<b>marantz®</b> <b>SERVICE BULLETIN</b>		Date: 31-Oct.-2003	Model: SR4300/SR4400
		Page: 1 / 3	REF.NBR: MZ03-047
Circulation:		Subject:	
Application:		The problem of the Speaker protection circuit.	
x for information customer complaint in case of service mandatory .....			
Service code XE00 XE00xxxxxxxxxx

<b>marantz®</b> <b>SERVICE BULLETIN</b>		Date: 30-June-2003	Model: SR4300,SR4400
		Page: 1 / 1	REF.NBR: MZ03-025
Circulation:		Application:	
x for information customer complaint in case of service mandatory .....		See Below	
		Subject: FM(with RDS) signal is received, Frequency Indication becomes the setup of default by the remote control operation . (only N and A version occurs)	
		Int.ref:

<b>marantz®</b> <b>SERVICE BULLETIN</b>		Date: 30-June-2003	Model: SR4300
		Page: 1 / 3	REF.NBR: MZ03-026
Circulation:		Application:	
x for information customer complaint in case of service mandatory .....		See Below	
		Subject: Noise is conspicuous by the conditions.	
		Int.ref:

<b>marantz®</b> <b>SERVICE BULLETIN</b>		Date: 28-Aug-2003	Model: SR4300
		Page: 1 / 1	REF.NBR: MZ03-033
Circulation:		Subject:	
Application:		There is a case that the power shut-down suddenly.	
x for information c

### SR4300

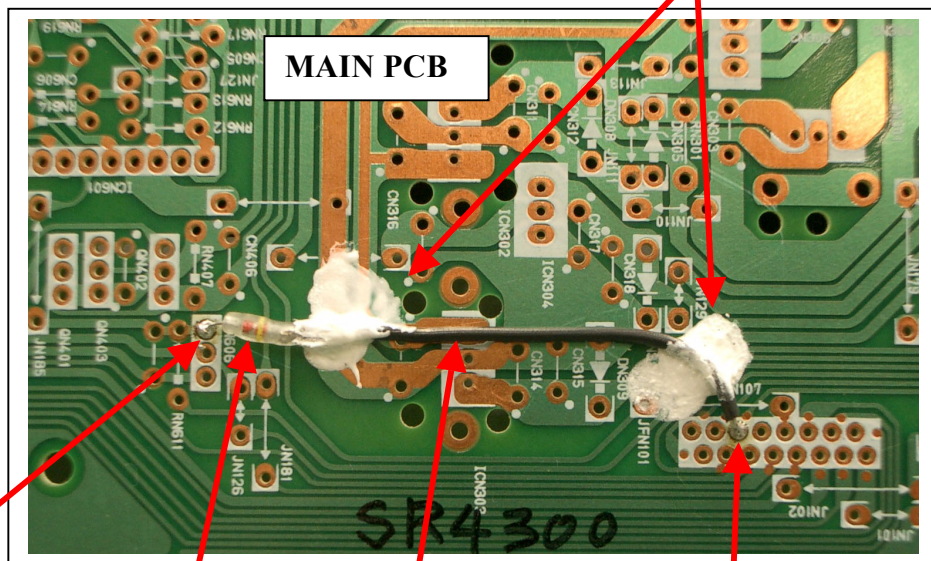
LS850 is changed to  
Part no. \*HD201810R

**Caution**  
JFS08 (FPC CONNECTOR) side is  
CATHODE

BASE of QN606

DN601  
Part no. HD20002000

No.5 pin of JFN101

Insulation tube is used

- 1) Chip Resistor **LS850** (100 ohm 1/16W part no. NN05101610 ) is changed to **Silicon Diode (Part no. \*HD201810R--- 1SS400 POHM: EMD2, EIAJ: SC-79, JEDEC: SOD-523 )**.

- 2) Chip Resistor **DN601(Part no.HD20002000---Silicon Diode 1SS254 ROHM)** is added between BASE of QN606 SEMICOM.COMP and No.5 pin of JFN101 Connector

SR4400

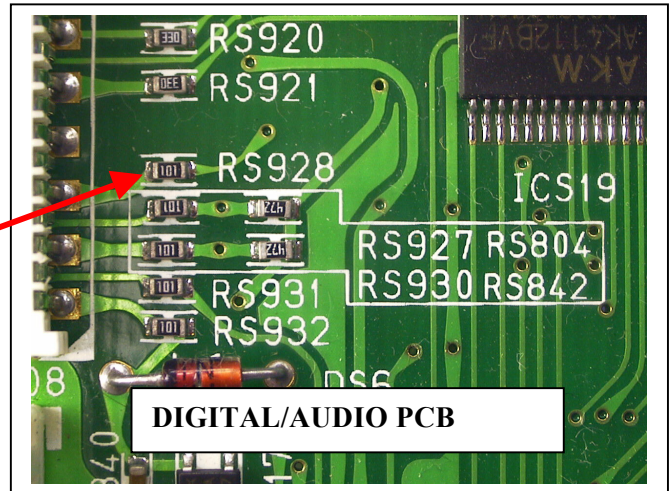
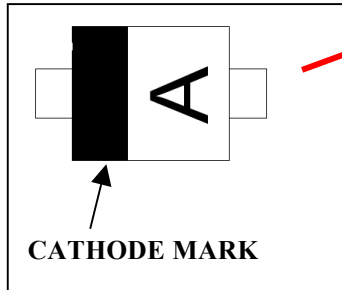
RS928 is changed to  
Part no. \*HD201810R

**Caution**  
JFS08 (FPC CONNECTOR) side is  
CATHODE

MAIN PCB

BASE of QN606

No.5 pin of JFN101

Insulation tube is used

DN601  
Part no. HD20002000

- 1) Chip Resistor **RS928** (100 ohm 1/16W part no. NN05101610 ) is changed to **Silicon Diode (Part no. \*HD201810R--- 1SS400 POHM: EMD2, EIAJ: SC-79, JEDEC: SOD-523 )**.

- 2) Chip Resistor **DN601(Part no.HD20002000---Silicon Diode 1SS254 ROHM)** is added between BASE of QN606 SEMICOM.COMP and No.5 pin of JFN101 Connector

Fig.1

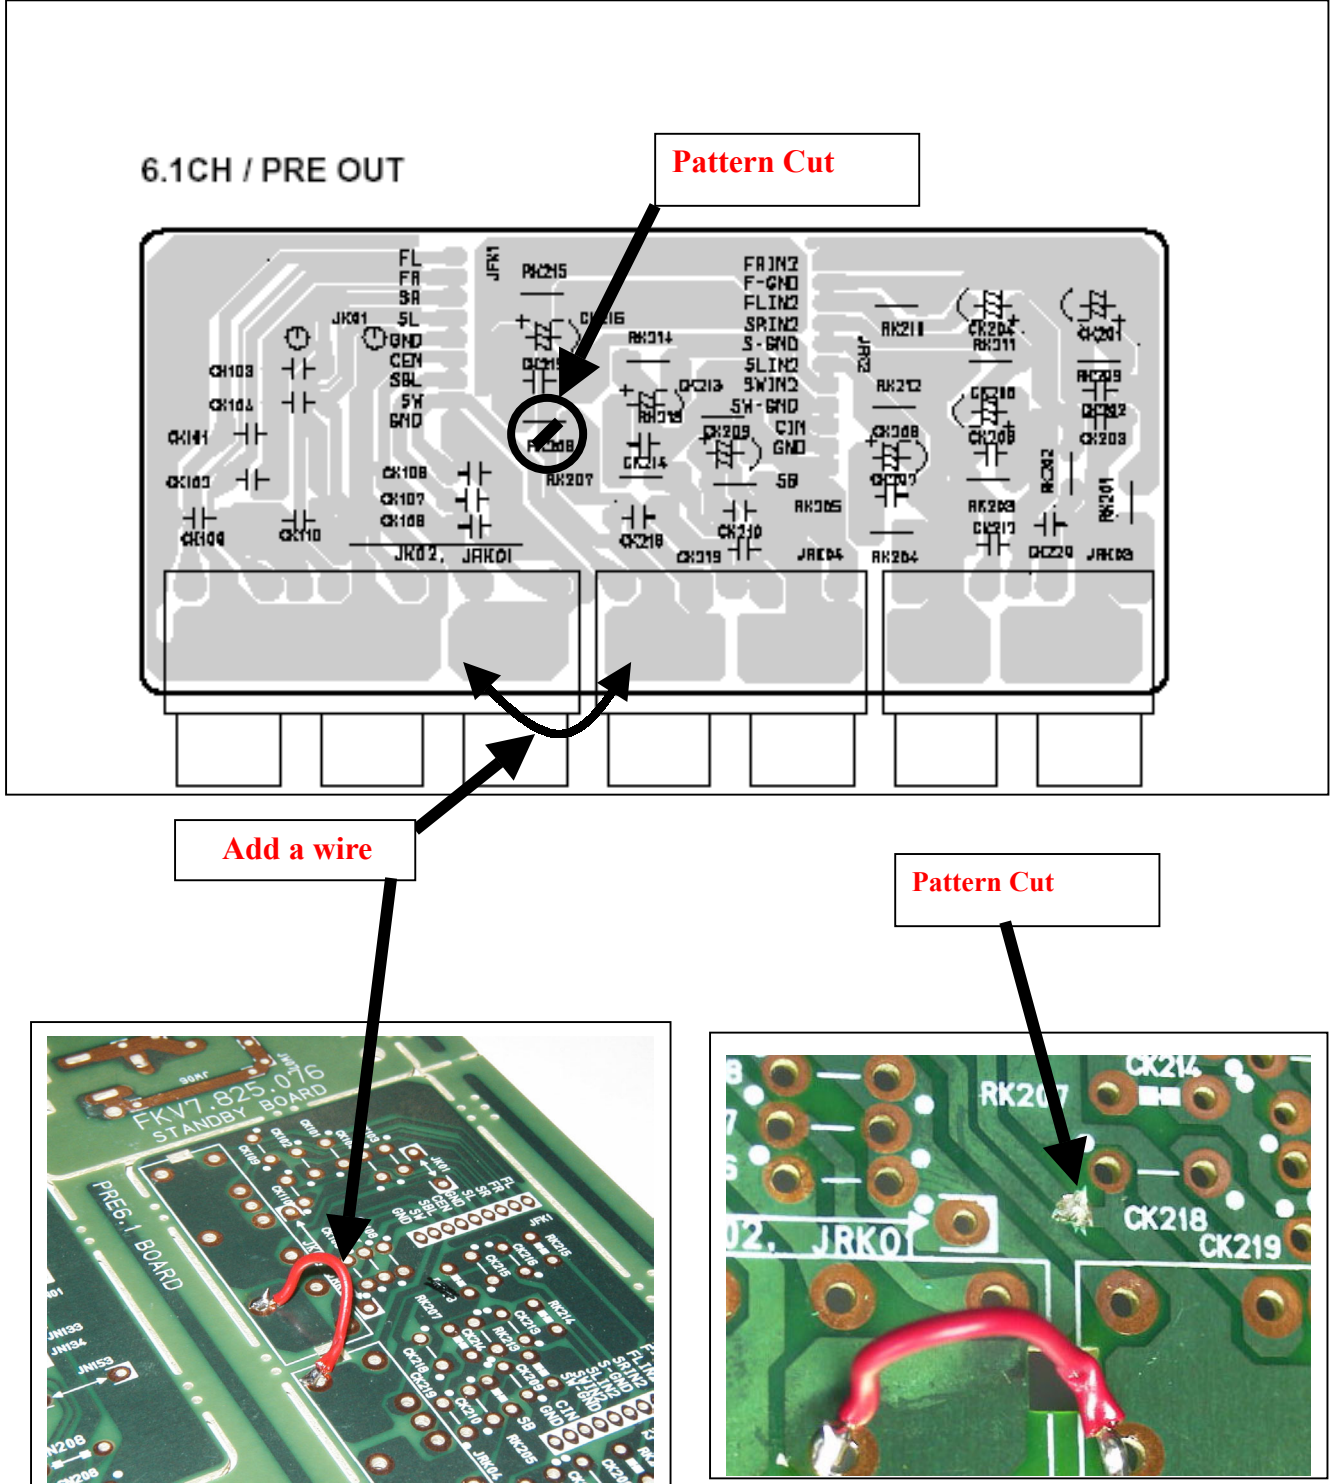
3. Cut a pattern. (please see Fig.1)
  4. Add a wire. (please see Fig.1)
  5. Twist the wire 5 times. (please see Fig.2)
- The 9pin wires are connected to JFS05(DIGITAL/AUDIO PCB) from JFK1(6.1CH/PRE OUT PCB)

Fig.2

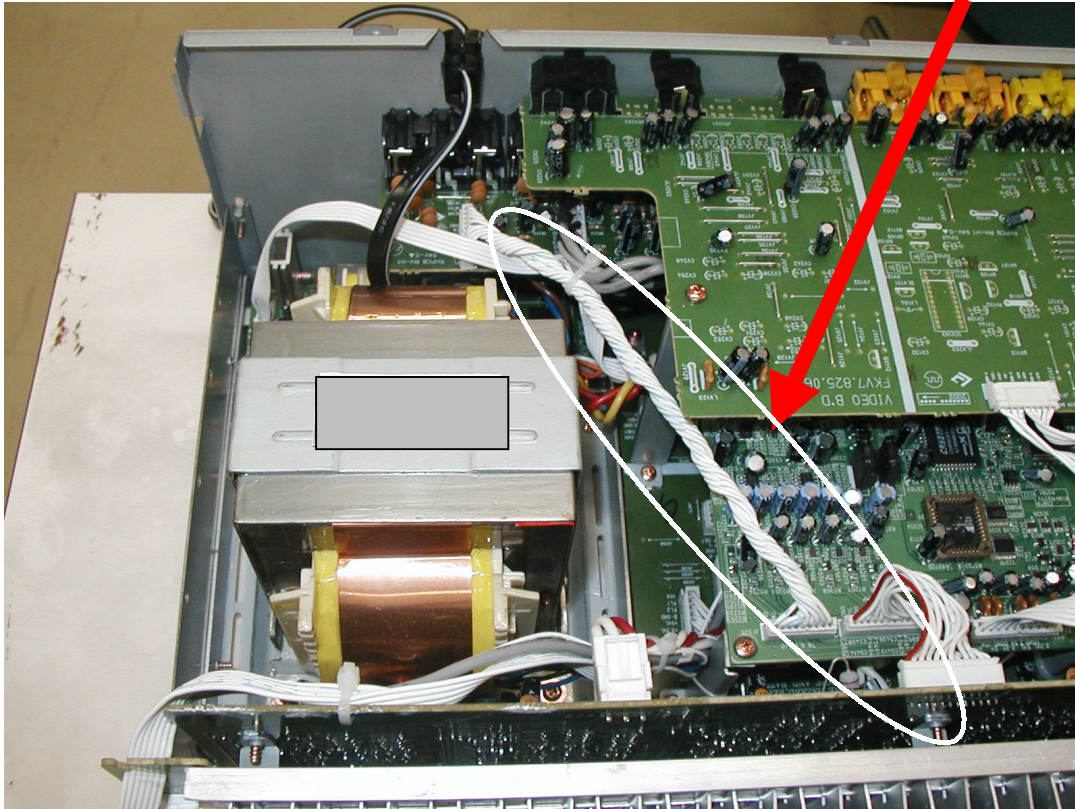
Twist the wire 5 times

RS870 (10 k ohm)

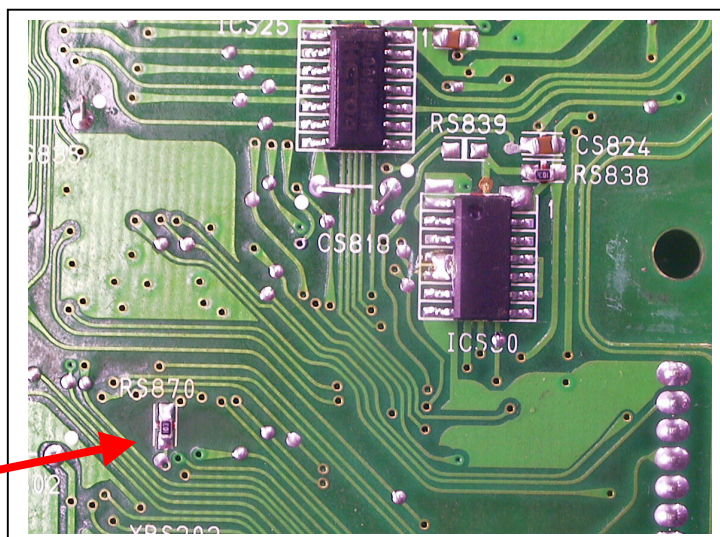
When the unit warms up, CPU clock stops, and the unit becomes a perfect stop.  
The capacitor (0.1uF) was mounted instead of resistor RS870(10 k ohm) .  
(When the PCB is repaired, it has the possibility that a capacitor (0.1uF) was used.)

RS870 is this side of DIDITAL/AUDIO PCB

1. Confirm whether **RS870** on DIGITAL/AUDIO PCB is **10 k ohm Chip resistor**.
2. The part which isn't right, changed to **10 k ohm Chip resistor (Part no. NN05103610)**.

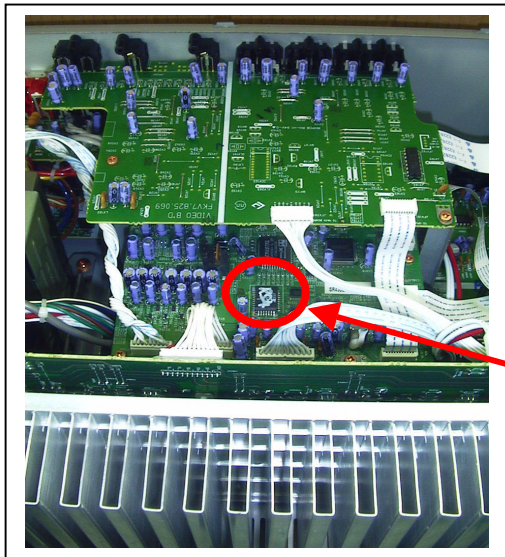
It occurs when “Speaker Size setup” is set as the right figure.

Speaker Size Setup	
SUBW (Subwoofer)	YES / <del>NONP</del>
L&R (Front Left&Right)	SMALL / <del>LARGE</del>
CENTER	SMALL / LARGE / <del>NONP</del>
SL&SR (Surround Left&Right)	<del>SMAL</del> / LARGE / NONE
SURR.B (Surround Back)	YES <del>NONP</del>
